**NOTICE OF MEETING
LANDMARK COMMISSION
OF THE CITY OF GALVESTON
MONDAY, JULY 7, 2025 - 4:00 PM
CITY COUNCIL CHAMBERS, 2ND FLOOR OF CITY HALL
823 ROSENBERG, GALVESTON, TEXAS
REGULAR MEETING**

25LC-022

RE: **25LC-022 (212 22nd Street)** Request for a Certificate of Appropriateness for modifications to the structure including a new canopy and a third floor addition. The property is legally described as Abstract 628 M.B. Menard Survey, Part of Lots 1 & 2 (1-1) Block 621, in the City and County of Galveston, Texas.
Applicant: Brax Easterwood, AIA
Property Owner: Catherine Buerger, Saint Buerger Property Management, LLC.

25LC-028

① Proposed Mechanical Mezzanine Plan
1/4" = 1'-0"

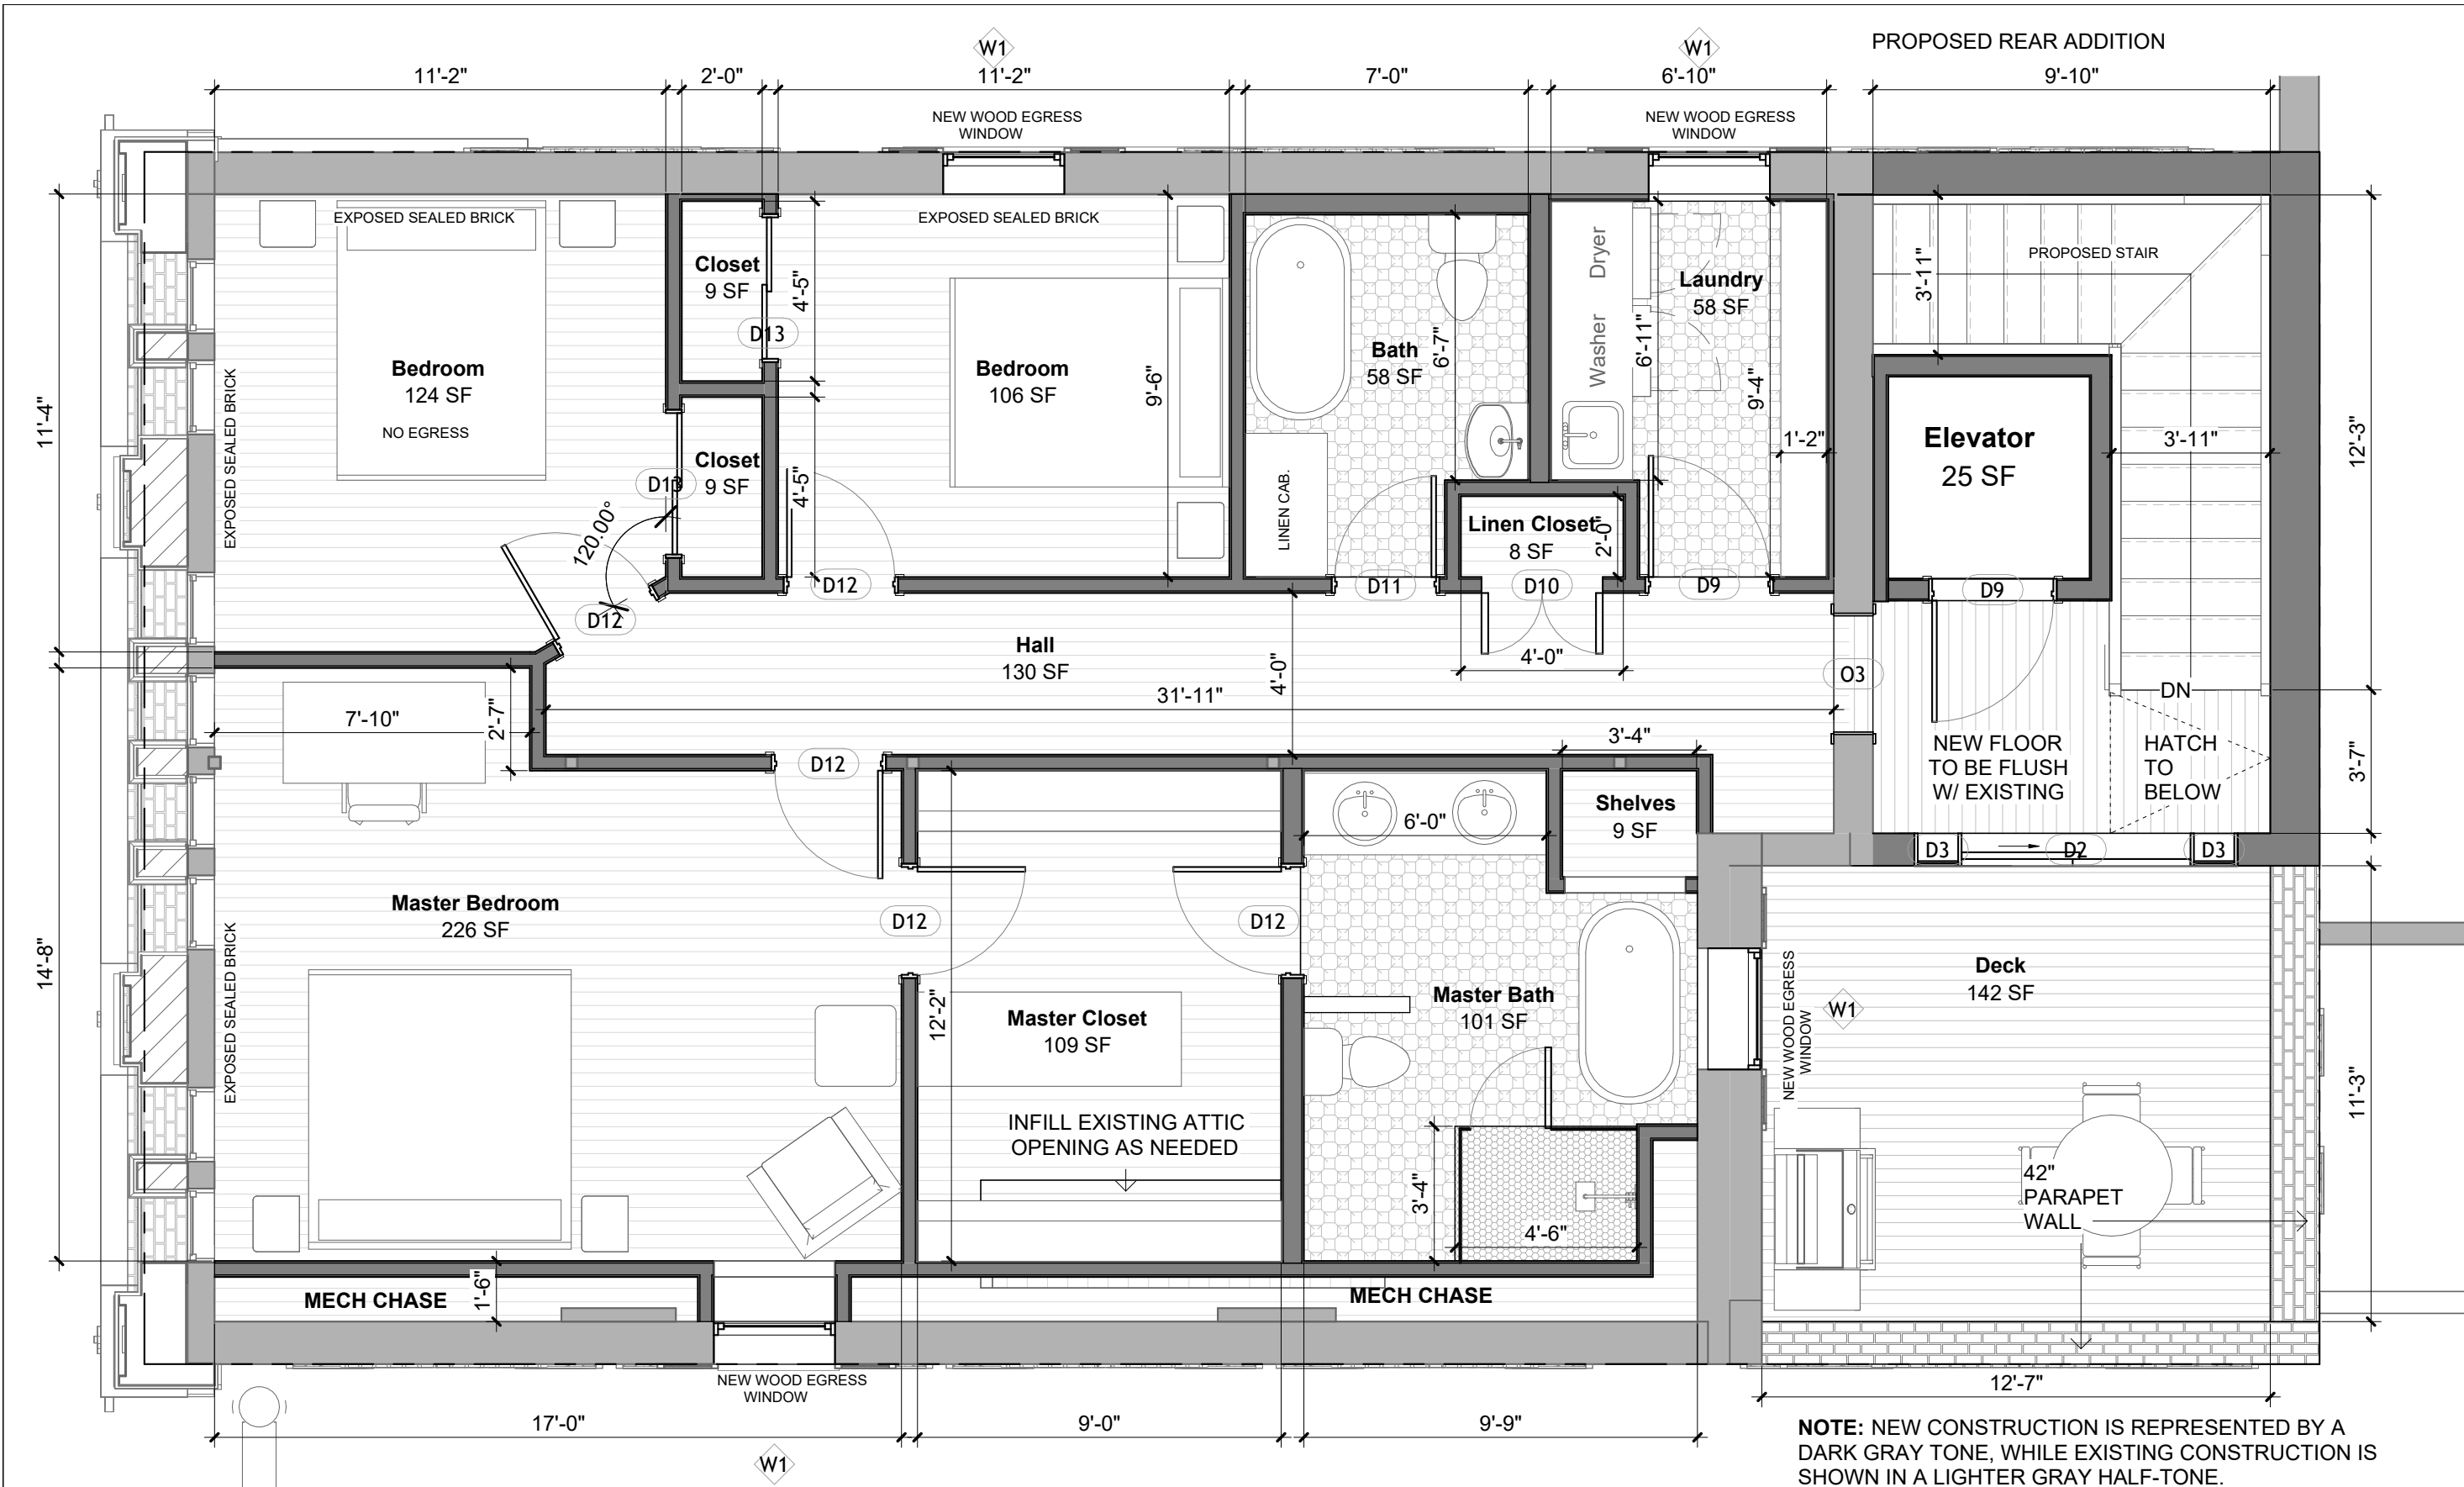
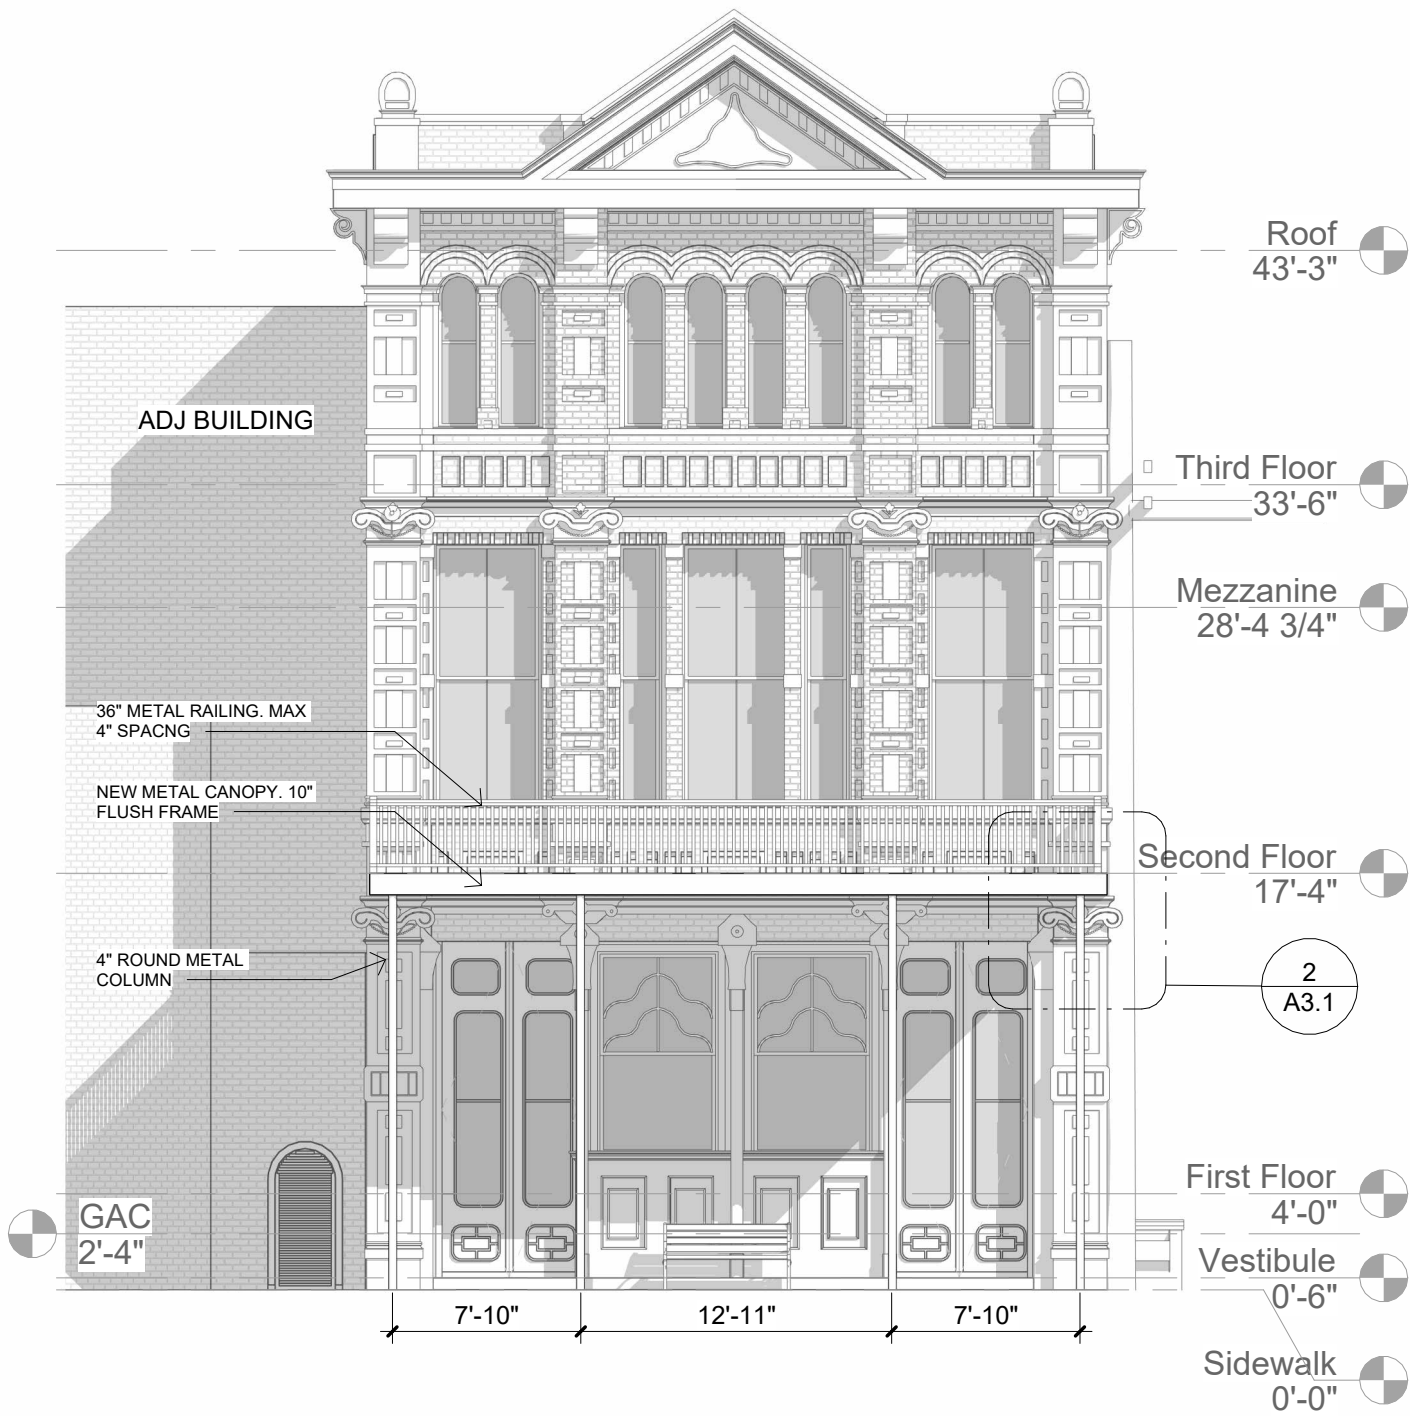
Staff finds that the request partially conforms to the Design Standards. The third floor / rooftop addition is located in Location B: Highly Visible Secondary Wall (preservation and repair in place is the priority) and Location C: Less Visible Secondary Wall (preservation is still preferred but additional flexibility exists for compatible replacement or alteration). However, the majority of the proposed changes are along the third story are well above eye level, and the north façade faces primarily other structures with little opportunity for pedestrian views.

For these reasons, staff recommends approval of those changes but recommends the use of one-over-one windows to clearly denote new windows in new openings. Staff also recommends setting the third floor additions back at least 18" from the historic façade if feasible; if not staff recommends adding some visual detail to differentiate the original walls from the historic brick to be added (such as a decorative brick course or trim piece). The applicant also proposes to add metal and wood shutters to the new window openings to match existing shutters; this conforms to the Design Standards.

1. The exterior modifications shall conform to the design, materials and placement presented in Attachment A of the staff report with the following modifications:
 - a. The rooftop additional shall be set back from the plane of the historic building along the mid-block alley (south façade) by 18 inches, or otherwise visually differentiated from the historic wall below if that is not feasible;
 - b. The new windows shall be of a one-over-one light configuration; and
